Environmental Control and Protection - Planning Consultation Response

To:	Joe Richardson Planning Officer
From:	Vicky Brown Senior Environmental Health Officer
Date:	01.11.2024
Planning Application Reference:	PL/2021/04084
Environmental Health Reference:	PR202406-259843
Description of Proposal:	Residential development of 49 no. new dwellings comprising development on land to the west of Roger Way (Areas A&F), alongside the change of use of the vacant ground floor unit at Block C of the Old Sarum Local Centre (Area G), to provide for 7no. affordable apartments.
Address:	Land to the west of Roger Way and Old Sarum Local Centre (Block C), Old Sarum, Salisbury, Wiltshire
Site Visited:	Yes
Recommendation:	Refusal

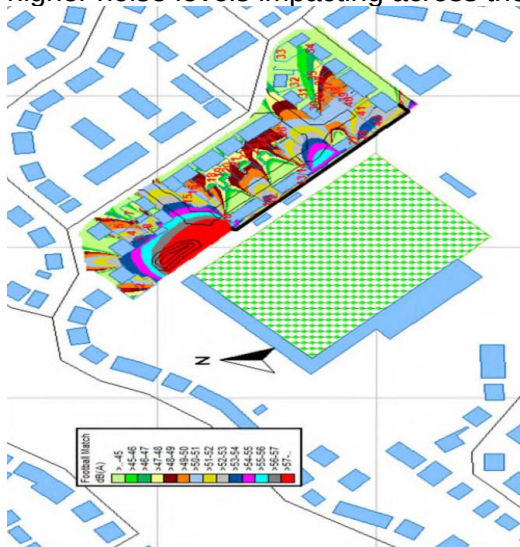
Unfortunately, it is still the case that even by the submitted acoustic consultants report a large proportion of dwellings would need to have their windows closed to meet the target internal noise level. The target noise level used is a LAeqT which is an equivalent continuous noise level over time. An LAeqT is a commonly used parameter but it does have the effect of levelling out peaks

In regard to site and internal layout, the blocks immediately on the boundary – plots 9-14 have been designed to be single aspect and this will provide some protection to the habitable rooms of these plots and some protection as a barrier to dwellings further away. However this block is not a continuous barrier block along the boundary and will not provide significant mitigation to noise from impacting on dwellings as can be seen in the contour diagram below. It should be noted that this is a contour diagram for daytime sound levels from the football match – so at ground floor level where there is some protection from the 2.5m high fence. A contour diagram for first floor would show higher noise levels impacting across the site.

Plots 1,2,3, 16-25, 30, 41 and 42 have living room and bedroom windows facing the football field or at right angles. The LAeq sound level is predicted to be up to 62dB at some facades, with an open

window providing 13dB attenuation this would be an LAeq of 49dB in the livingroom or bedroom during a match. This is 19dB higher than the level recommended for anonymous noise in a bedroom and 14dB higher than the level recommended for anonymous noise in a livingroom. In addition it must be considered that this is the average, there will be bursts of noise much louder than this. Again, even if residents choose to close their windows the bursts of impulsive noise are likely to be intrusive.
